RESPONSE TO REQUEST FOR ADDITIONAL INFORMATION

US-APWR Design Certification

RAI NO.: NO. 1060-7285 REVISION 4
SRP SECTION: 03.07.02 – Seismic System Analysis
APPLICATION SECTION: 3.7.2
DATE OF RAI ISSUE: 11/15/2013

QUESTION NO. 03.07.02-231:

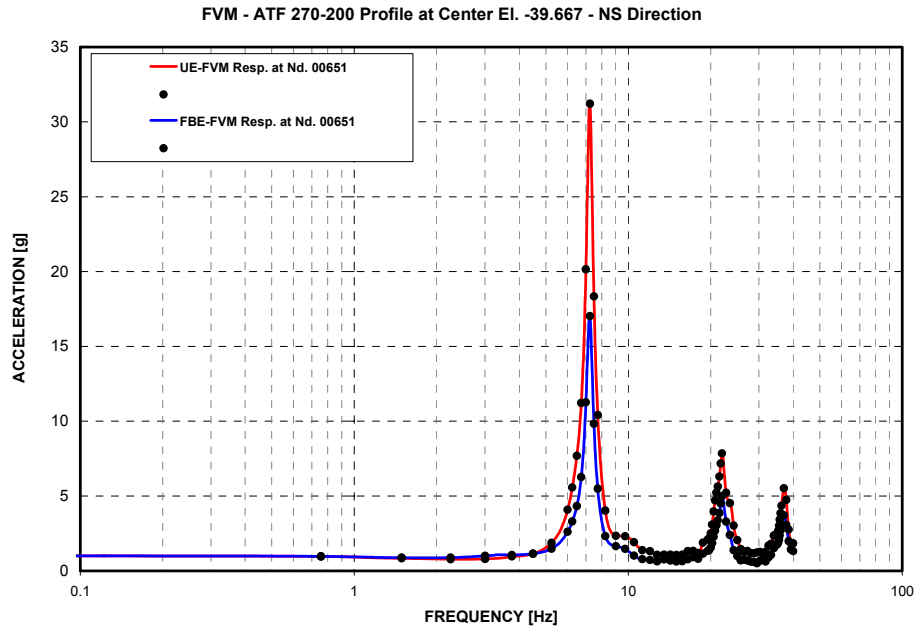
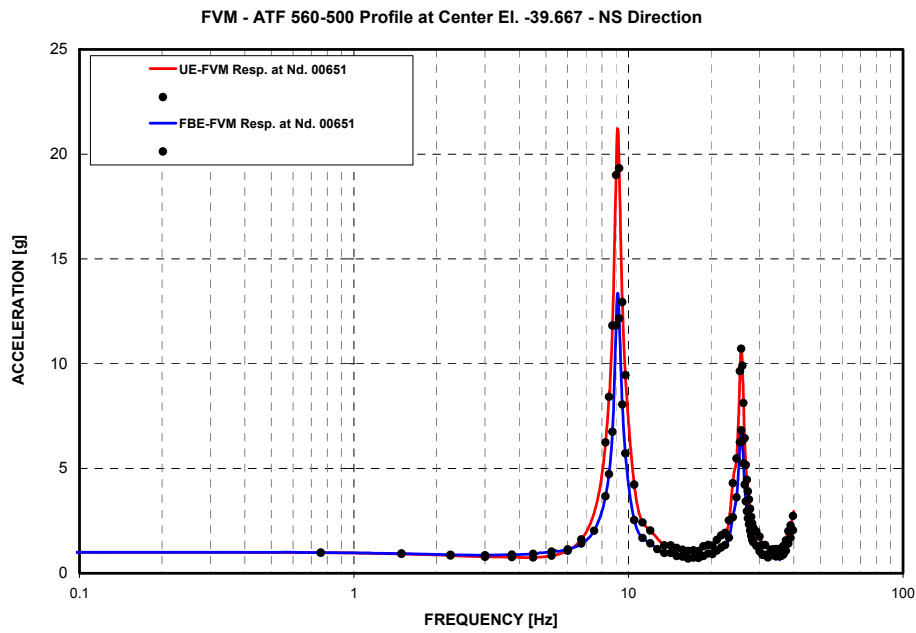
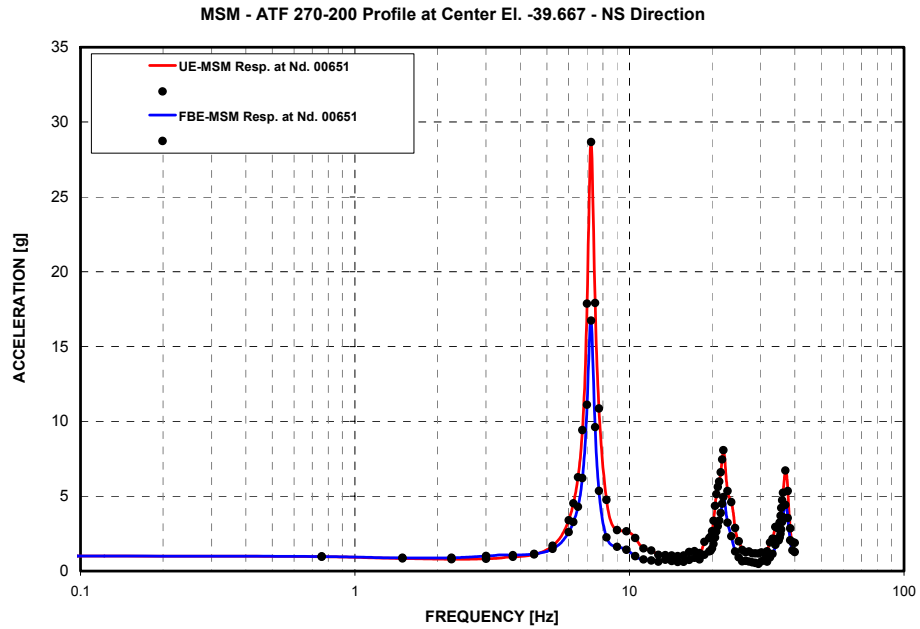
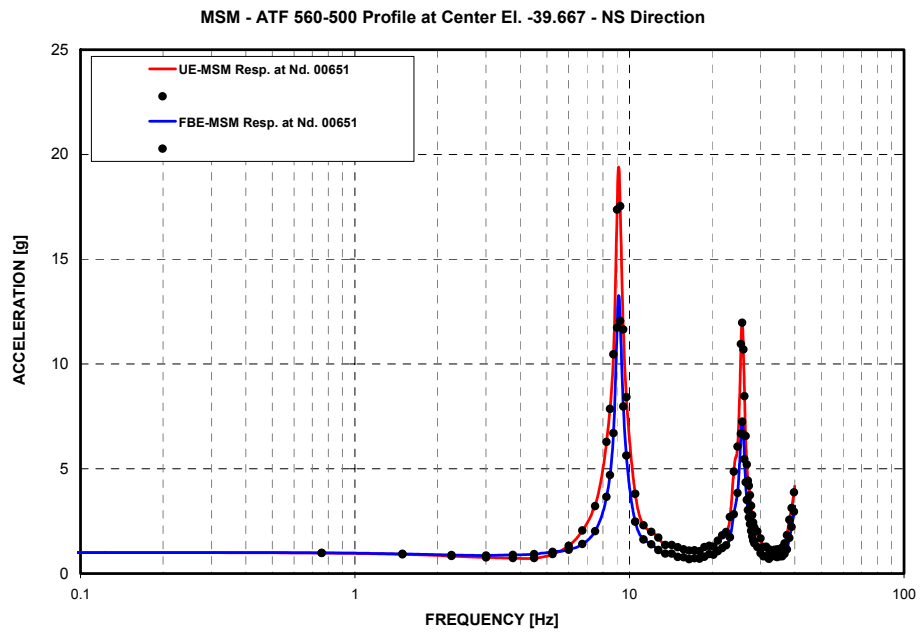
- (4) The bonding of the embedded structure to the side soil differs in the studies described in the RAI response and in the design basis analysis described in the technical report MUAP-10006, Revision 3. The comparison study denoted "study 1" in the RAI response considers both unbonded and fully bonded cases, but the comparison study denoted "study 2" considers only the unbonded case. In MUAP-10006, Revision 3, on the other hand, only fully

bonded conditions are considered. To assess the impact of the unbonded vs. bonded assumption, provide additional figures that compare the results for the unbonded vs. bonded cases that correspond to Figures 1 through 4 in the RAI response (study 1).

- (4) Acceleration Transfer function (ATF) comparison plots obtained from the Study 1 for unbonded vs. fully bonded are provided as shown in Figure 2 through Figure 5. The corresponding 5% damped Acceleration Response Spectra (ARS) comparison plots are provided in Figure 6 through Figure 9. In both the ATF and the ARS plots, the unbonded

case (UE) is represented by a red line and the fully bonded case (FBE) is represented by a blue line. Please note that the comparisons are made for the response from kinematic interaction only. See response to Question 03.07.02-233 Part 2 for the embedment condition effects on the seismic response of the R/B complex including both effects of inertia and kinematic interactions.
